File 1985-0024

Project Name Little Bookcliff CMI Housing Unit - Final Plan

REVIEW SHEET SUMMARY

SITE PLAN

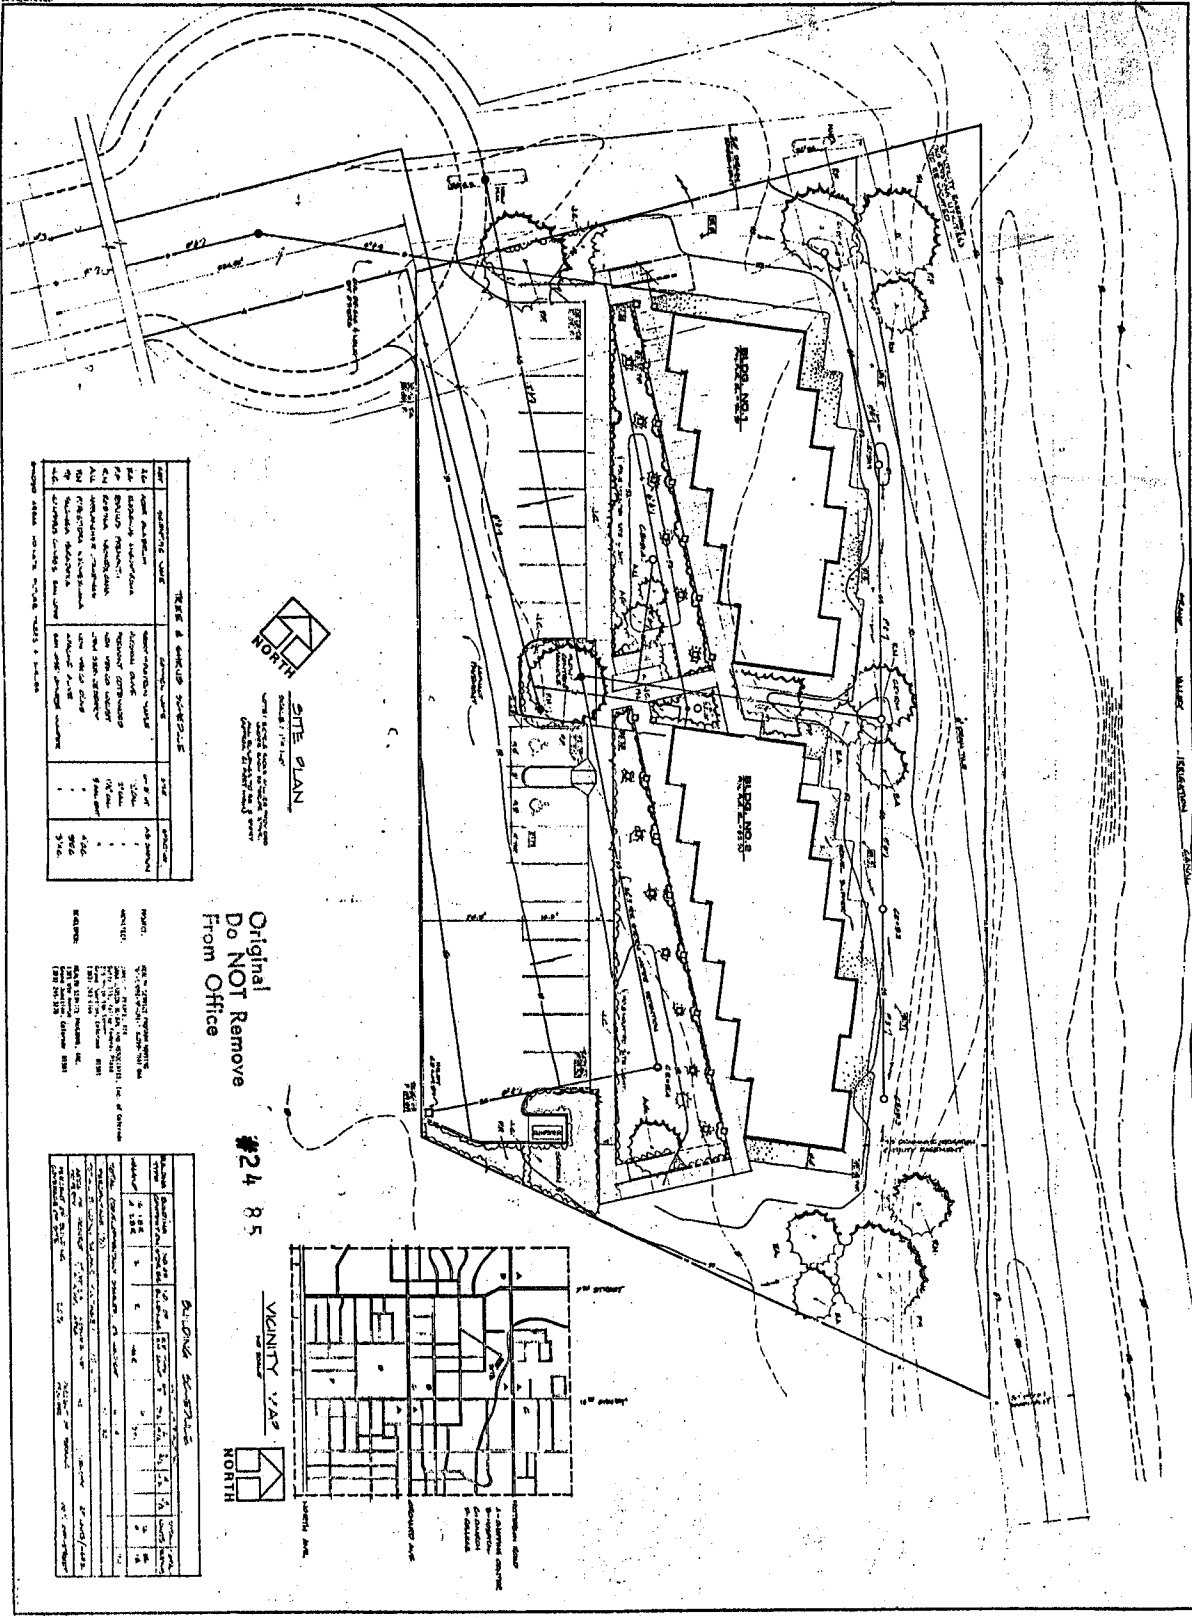
<u>DATE REC.</u>	<u>AGENCY</u>	<u>COMMENTS</u>
9/4/85	Building Dept.	Colorado State law requires that a state licensed architect design the structures. Soils test for foundation design is required. Would recommend early submittal of architectural drawings for review for Code compliance. Drainage is extremely important on this site.
9/6/85	Mtn. Bell	No objections.
9/9/85	Parks & Rec.	Landscaping okay. If this qualifies for open space fee, we need appraisal.
9/9/85	Public Works	Who is going to build the cul-de-sac shown on the site plan? A drainage study must be submitted for review by the City Engineer and Grand Junction Drainage District. What is the pipe system shown on the site plan which is labeled SS? What is the pipe system labeled S? Will need more information on these pipelines. Scale on site plan is wrong!
9/12/85	Development Dept.	<p>This request for 20 unit housing in a Planned Business Zone is proposed as one phase. It was rezoned from multi-family to business in 1984 to accommodate a medical facility on one lot. Because of the existing uses and location proposed, this use does not present a problem in terms of current compatibility. The PB zone does allow residential if approved that way. Future uses proposed may have the compatibility question raised. The vacation request will be handled under separate submittal.</p> <p>The soils and subsurface soils reports make recommendations regarding building and irrigation concerns, due in part to the closeness of the lot to the Grand Valley canal. These recommendations should be followed to minimize water problems.</p> <ol style="list-style-type: none">1. Do any of your "clients" ride bikes? If so, any bike racks should be provided (as noted on the plan) in areas easily accessible.2. Some info. on the building appearance would be helpful for the Hearing.3. Regarding the public right-of-way - some type of commitment (e.g. escrow, building improvements guarantee, etc.) will be required to ensure public right-of-way is, or will be, constructed. The design will have to be approved by the City Engineering Department.4. You know your current clients; however, if this is sold or converted to regular housing, additional parking would be required. Can provisions to accommodate additional parking (if needed in the future) be provided now? The proposed layout is acceptable for the proposed use.5. Landscaping, as shown, is acceptable; however, some buffering or screening, both in rear and front may be recommended. This will screen future businesses and also provide some security from the canal, both for these residents and others.6. Trash pickup location should be confirmed with City's Public Works Department.

- 9/13/85 Public Service Gas: No objections.
- Electric: *?* Request that the existing 40' easement on the north continue to the west property line.
- 9/13/85 Fire Dept. Buildings must meet Uniform Fire and Building Code requirements for this type of occupancy. The Fire Dept. has some concern about the life safety for the mentally ill and would highly recommend that an automatic residential sprinkler system be installed in the buildings. This would provide life safety for the occupants and also protection for the buildings, which in turn would reduce insurance costs on the buildings. Polybutylene pipe has been approved by Underwriters Laboratories for this type of occupancy, which will reduce the initial cost of the spinkler system. Please communicate with the Fire Prevention Bureau concerning this.

- 1) Seller of property to build cul-de-sac and road as shown on site plan. This is spelled out in Seller/Buyer Contract for Sale, previously submitted to the Development Department;
- 2) A drainage study has been previously submitted. Please have Public Works contact Kelly Wilson of Dana Larson Roubal Inc. (our architect) for any additional information they may need;
- 3) SS = storm sewers; S = sanitary sewer;
- 4) Scale should read 1" = 10'.

- 1) Bike racks are shown on site plan as being located under exterior stairs;
- 2) A model of the building was provided at the public hearing;

- 3) Regarding the public right-of-way, please see the response to C1 above;
 - 4) A parking survey of current Mental Health Center clients show approximately 10% own vehicles. Our plans show 18 spaces, almost a 1:1 ratio. Clients will be low-income and therefore will not have boats, RV's, etc. If project ever sold, additional area of 18 spaces could be provided. Sixteen of 20 units are one-bedroom;

- 5) A fence will be constructed along north end of property to screen and provide security from canal;
 - 6) Trash pickup will be confirmed with Public Works;

- 7) Exterior lighting is shown on site plan and will be standard pole-mounted lighting;
 - 8) Vacation and rededication of easement will be handled under separate submittal;

- 9) Housing Authority, as managing agent, should be contacted first for any maintenance problems.
- E) Public Service
- 1) There is no existing 40' easement on the north. Please clarify this item.
